TECHNICAL BULLETIN INDEX
Sorted by Bulletin Number
04/03/86

DATE: November 3, 1980
 REVISION DATE: January 17, 1983
 BULLETIN NO.: CC:1
 PRODUCT: 26-3001/2 Color Computer
 SUBASSEMBLY: N/A

FIGURE 3
REVISION 'D' AND 'E' COMPONENT SIDE JUMPERS (SEE TEXT)

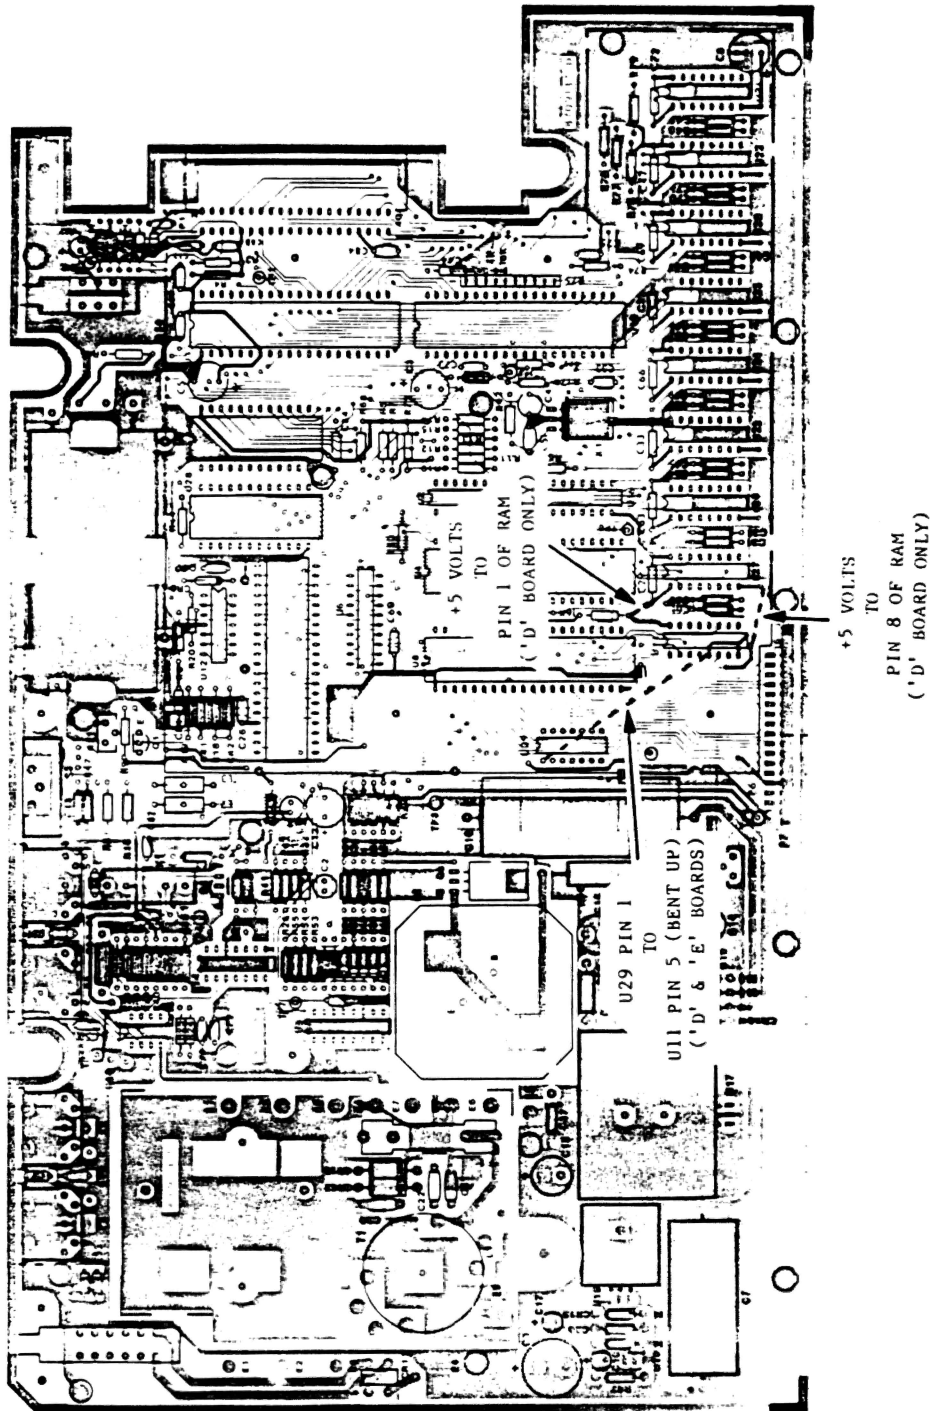
- 13) Remove U11 from its socket, and bend pin 5 upwards. Replace U11 in its socket.
- 14) Using small diameter (20 gauge) insulated wire, install the following jumpers on the COMPONENT side of the PCB. Refer to Figure 3 for proper location.

- 15) Using wire wrap wire, install the following jumper on the COMPONENT side of the PCB. Refer to Figure 3 for proper location.

- 18) Using wire wrap wire, install the following jumper on the COMPONENT side of the PCB. See Figure 3 for location.

FIGURE 4
REVISION 'D' FOIL SIDE JUMPERS

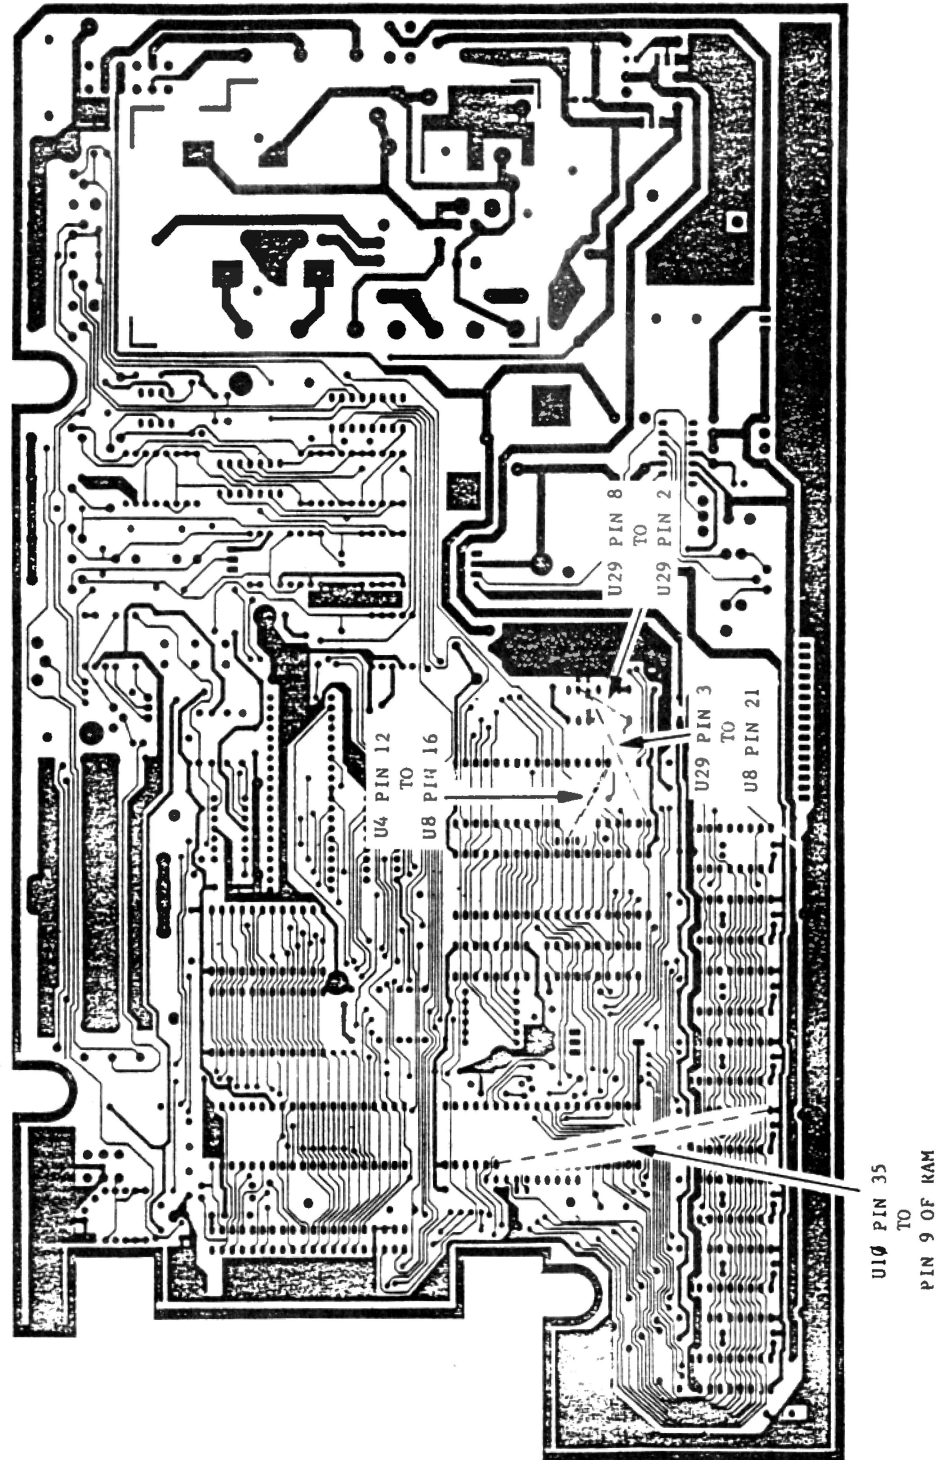
16) Using wire wrap wire, install the following jumpers on the FOIL side of the PCB. See Figure 4 for location.

FIGURE 5
 REVISION 'E' FOIL SIDE CUTS AND JUMPERS

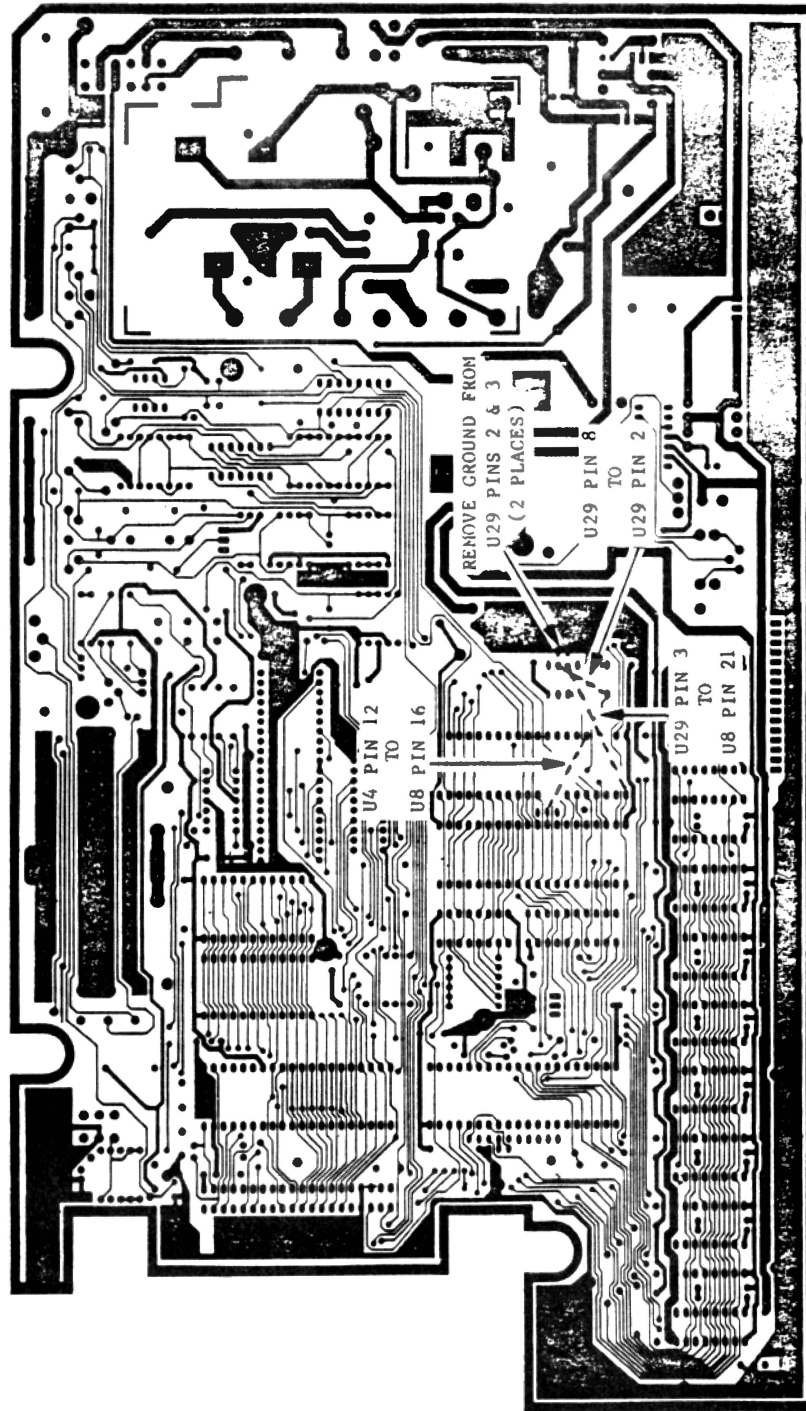
- 15) Make the following cuts on the CIRCUIT side of the PCB. Refer to Figure 5, and cut EXACTLY where indicated.

- 16) Remove U11 from its socket, and bend pin 5 upwards. Replace U11 in its socket.
- 17) Using wire wrap wire, install the following jumpers on the FOIL side of the PCB. See Figure 5 for location.

FIGURE 1

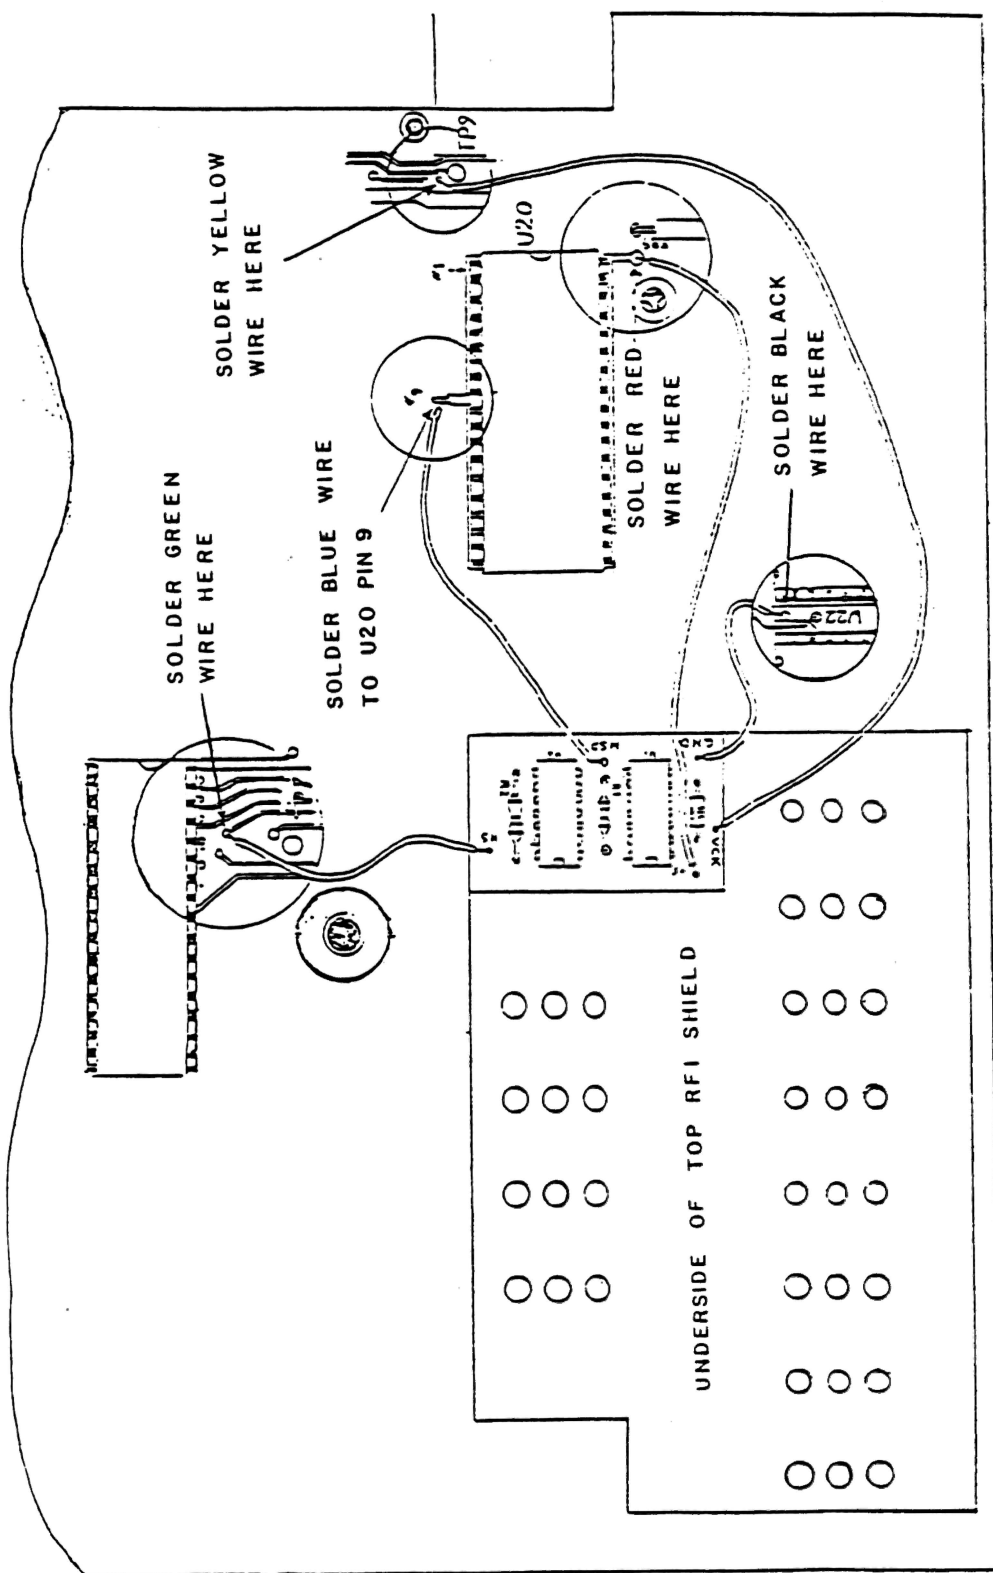
- A) Remove the logic PCB from the case. Remove the top RFI shield from the main PCB. Remove the bottom RFI shield from the main PCB and set it aside until later. Lay the top RFI shield upside down on top of U17 and U18, oriented as shown in figure 1.

- B) Remove the paper backing from one piece of foam tape supplied. Apply the foam tape to the upper right hand corner of the RFI shield. Place the satellite PCB onto the foam tape, with the component side up. Orient the satellite PCB so that R2 is closest to the top edge of the shield. See Figure 1.

- C) Solder the GREEN wire to the feed-through hole on the main PCB which is located 1/8 inch below pins 36 and 37 of U9. See Figure 1.
- D) Solder the BLACK wire to the feed-through located between U21 and U22. The feed-through is located just above the letters "U22". See Figure 1.

- E) Wrap and solder the BLUE wire to U20 pin 9, the pin bent out of the socket. See Figure 1.
- F) Solder the RED wire to the feed-through located 1/4 inch below U20 pin 40. The feed-through is located just above the letters "FB9". The trace leaving the feed-through goes directly to U20 pin 40. See Figure 1.

- G) Solder the YELLOW wire to the feed-through just above TP9. TP9 is located to the right of U20. See Figure 1.
- H) Remove the paper backing from the remaining piece of foam tape supplied. Apply the foam tape to the satellite PCB, attaching it to the top of the ICs.

FIGURE 1

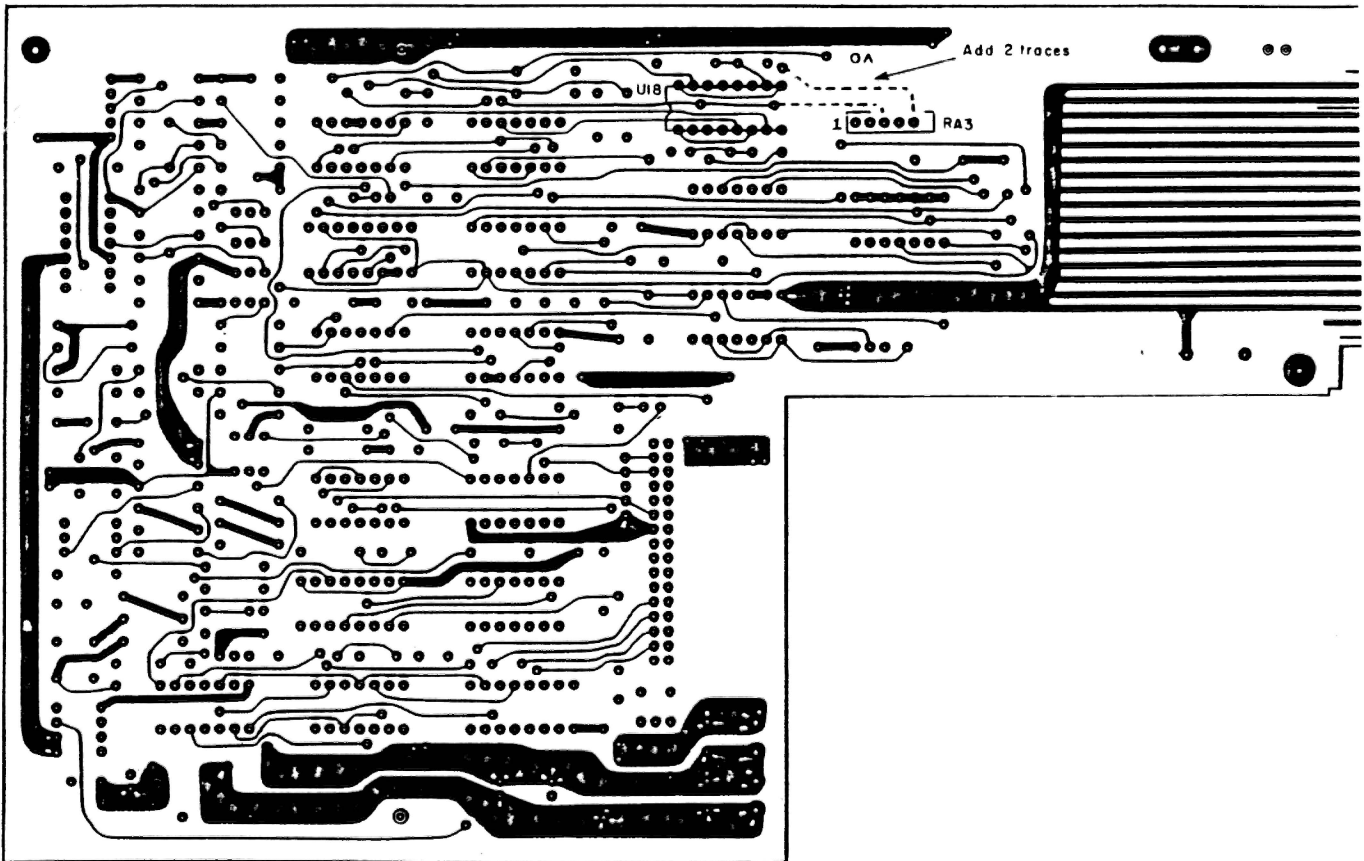
Add the following jumper wires to the FOIL side of the PC board. Refer to Figure 1.

- 1) Add a jumper from RA3 pin 5 (the pin closest to the edge card fingers) to the feed through next to U18 pin 8.
- 2) Add a jumper from RA3 pin 3 (the middle pin) to the feedthrough between U18 pins 8 and 9.

After modification the board should be checked and realigned if necessary.

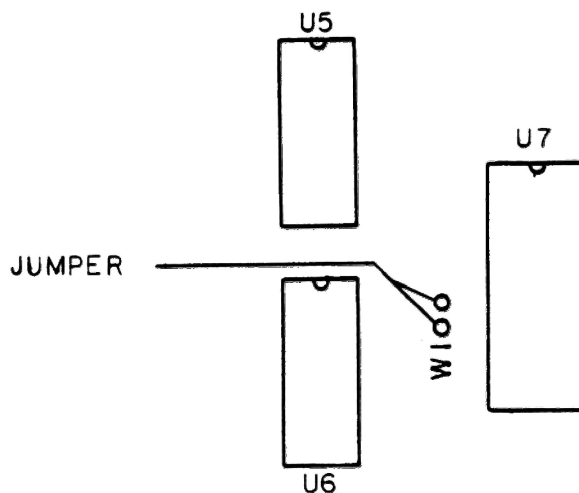
A 'W1' is marked on the main PCB between U7 and U6, as shown in the diagram below. Jumper the two plated-through holes immediately adjacent to the W1 symbol. Change the RAM chips U14 through U21 to 26-3017 64K chips. There are no capacitors to remove. Following this procedure the Color Computer 2 will be capable of running OS-9 or any other software that requires 64K of RAM.
